Review of Proposed Sewage Works

Lot 28, Concession 9, Wahwashkesh Lake, Municipality of Whitestone, ON

Pinchin File: 318638

CONCEPTUAL LAYOUTS FOR SEWAGE WORKS

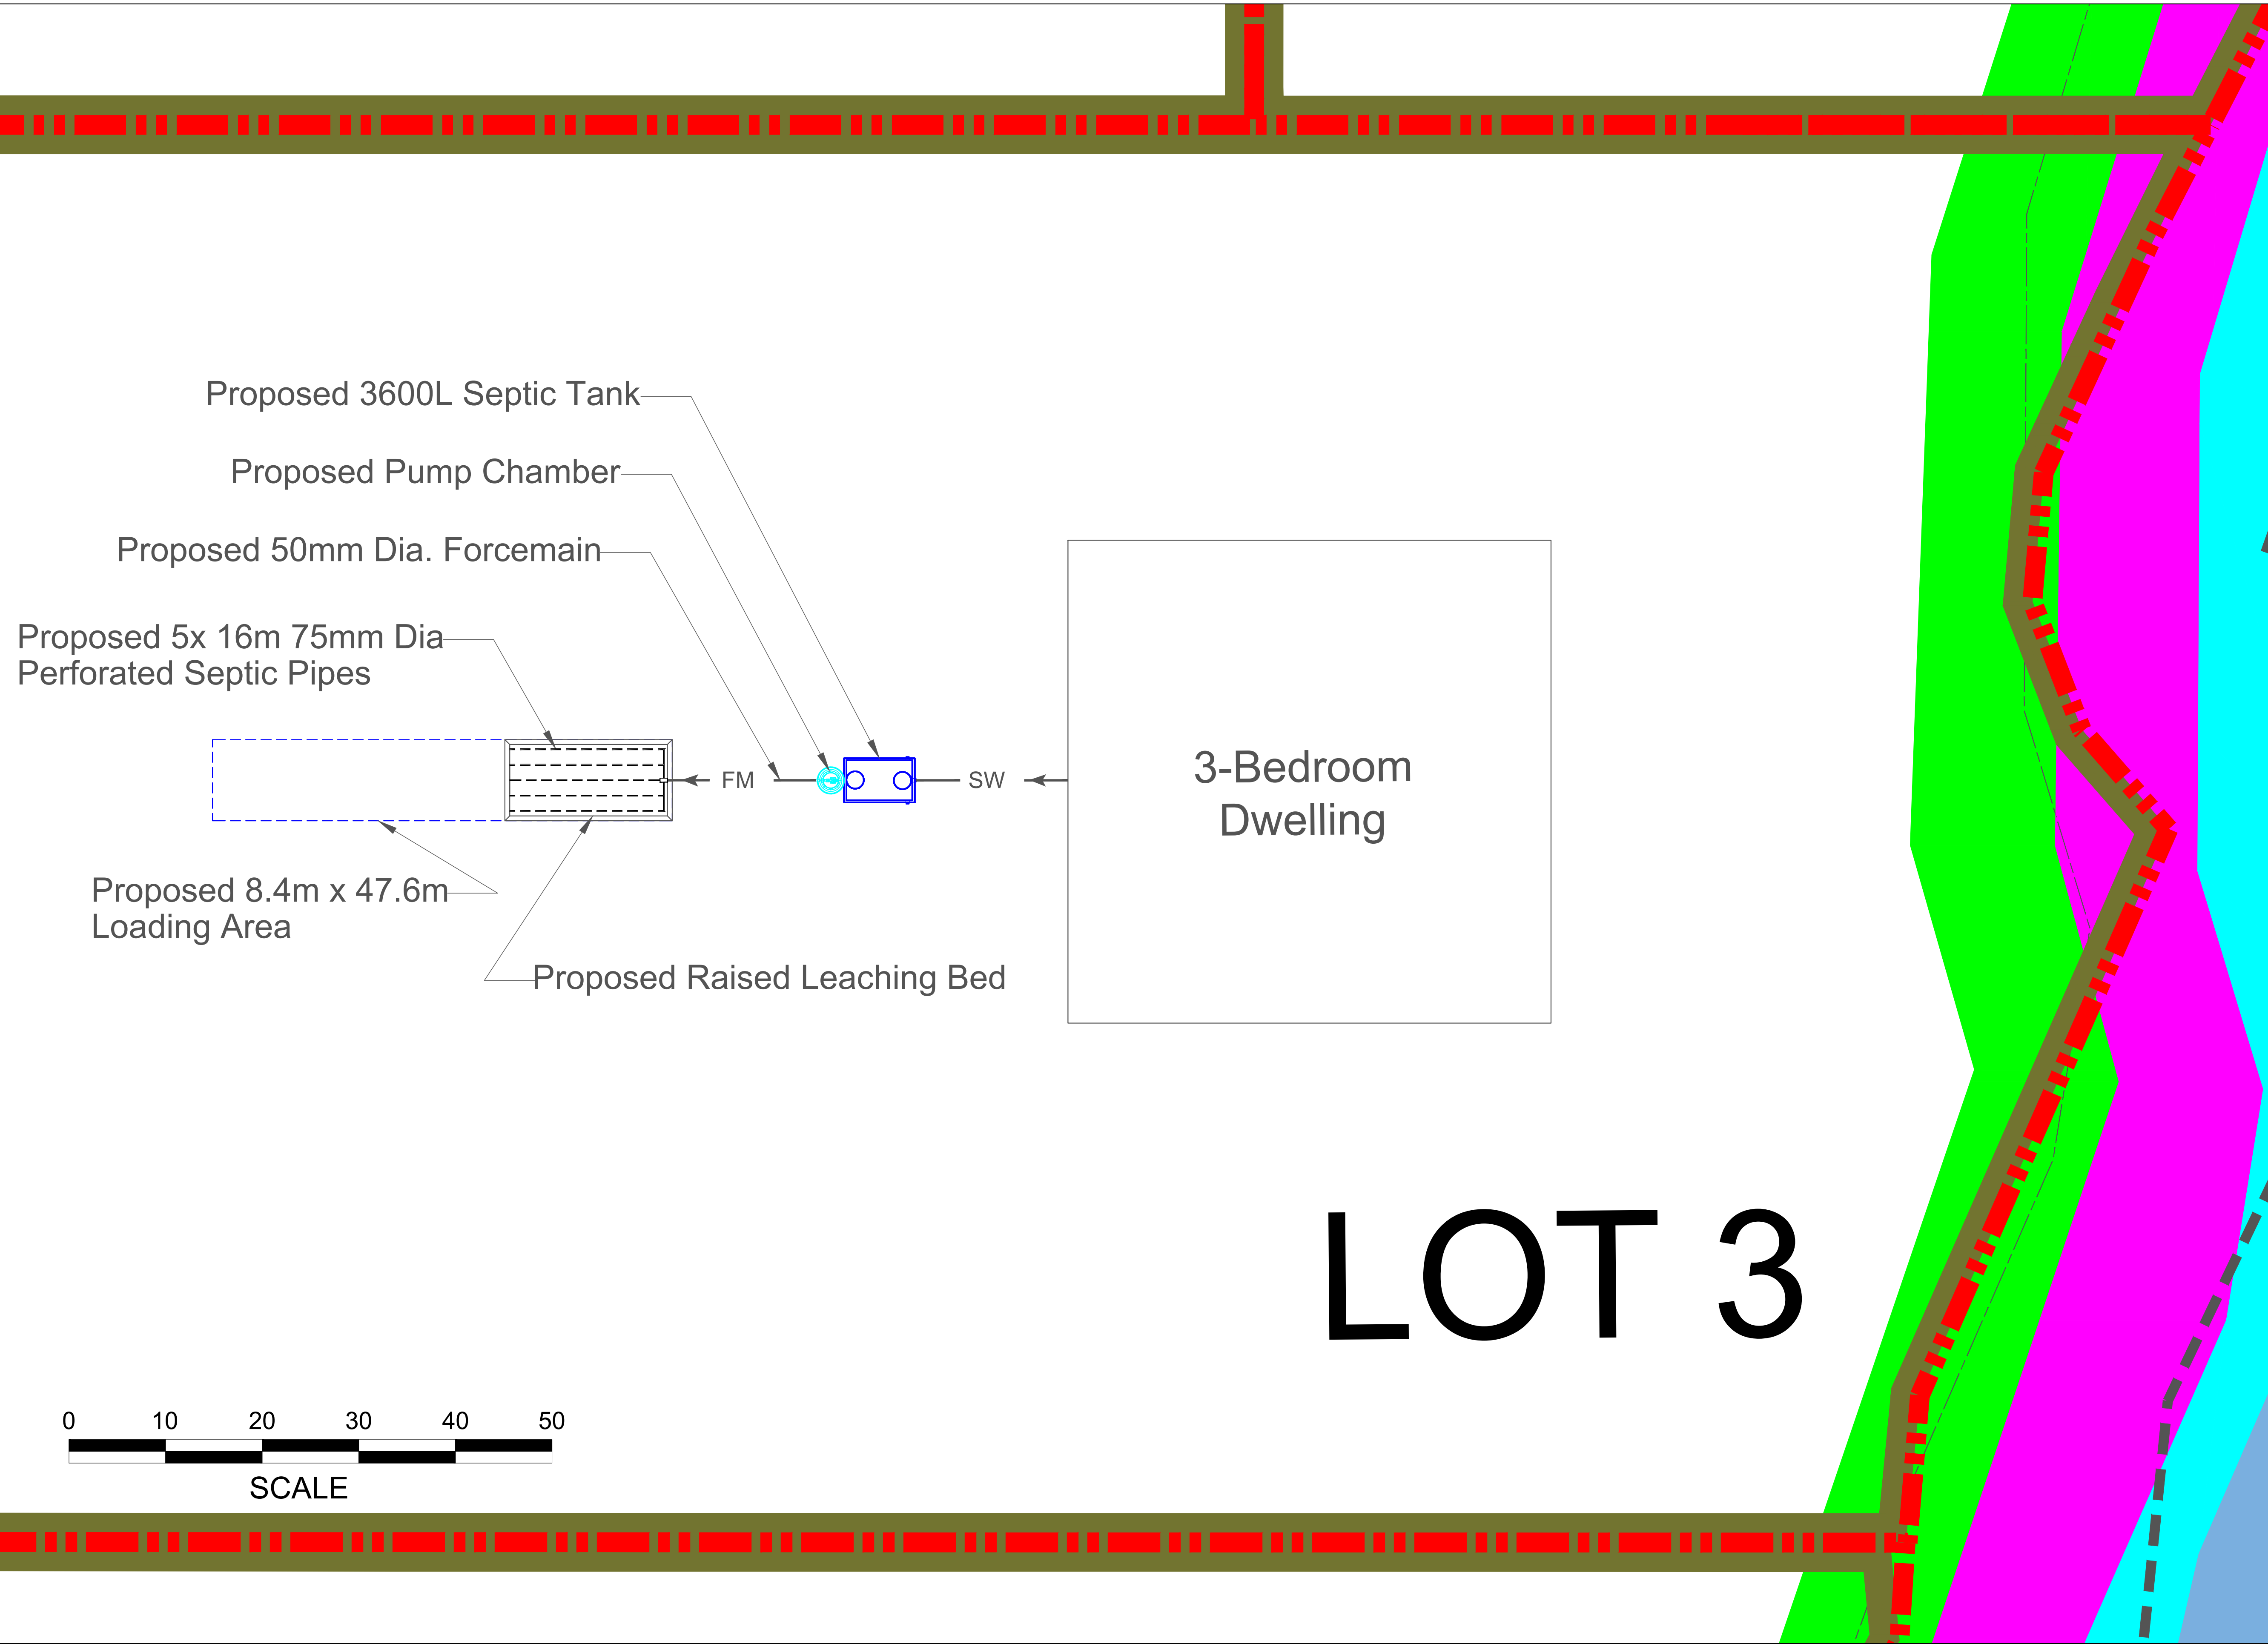
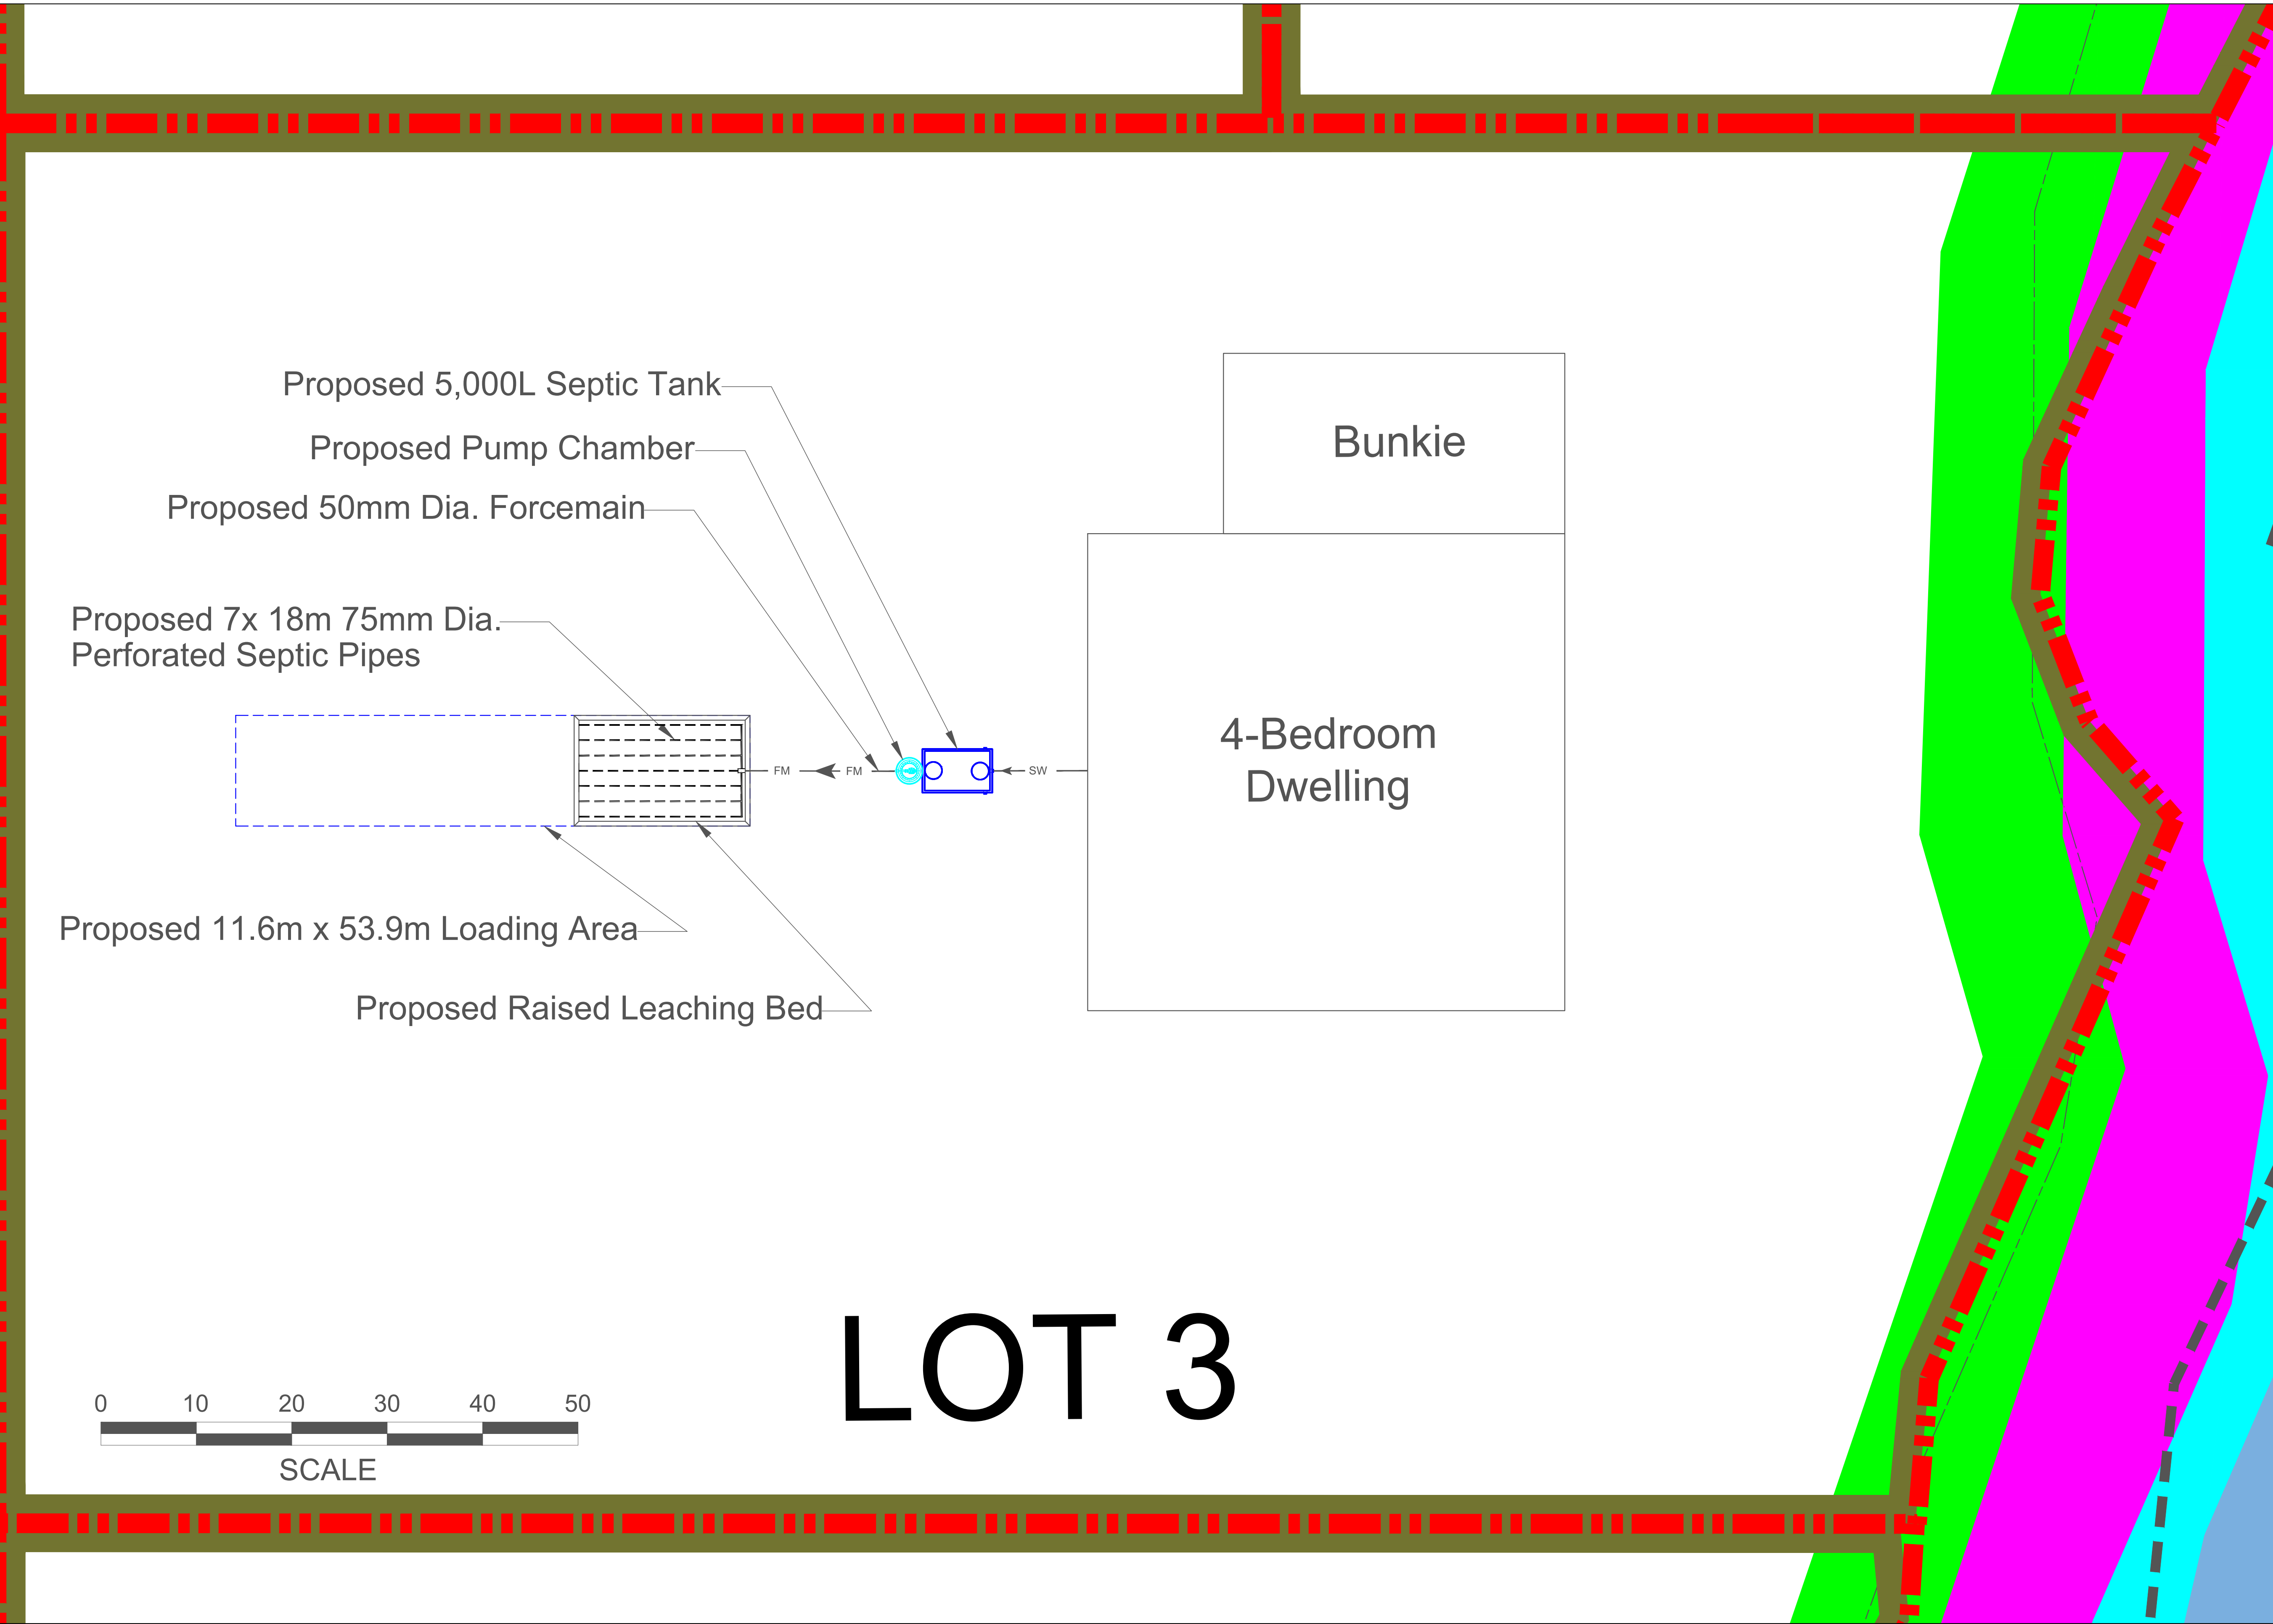
See Appendix III for conceptual layouts for a three (3) bedroom and five (5) bedroom dwelling with associated sewage works.

1. The sewage works only be construction in locations with a minimum starting elevation of 229.57masl and be setback from this elevation so that they,<the sewage works>, meet the minimum requirements of the OBC and the Whitestone Septic Policy. This will allow the sewage works to avoid the high-water level, thus meeting the requirements of the OBC, and maintain proper operation in the event of a flood; and
2. For all lots, determine the maximum footprint and occupancy (no. of bedrooms) of the proposed dwellings that will allow the sewage works to be installed such that they meet the requirements and setbacks of the OBC of the Whitestone Septic Policy.
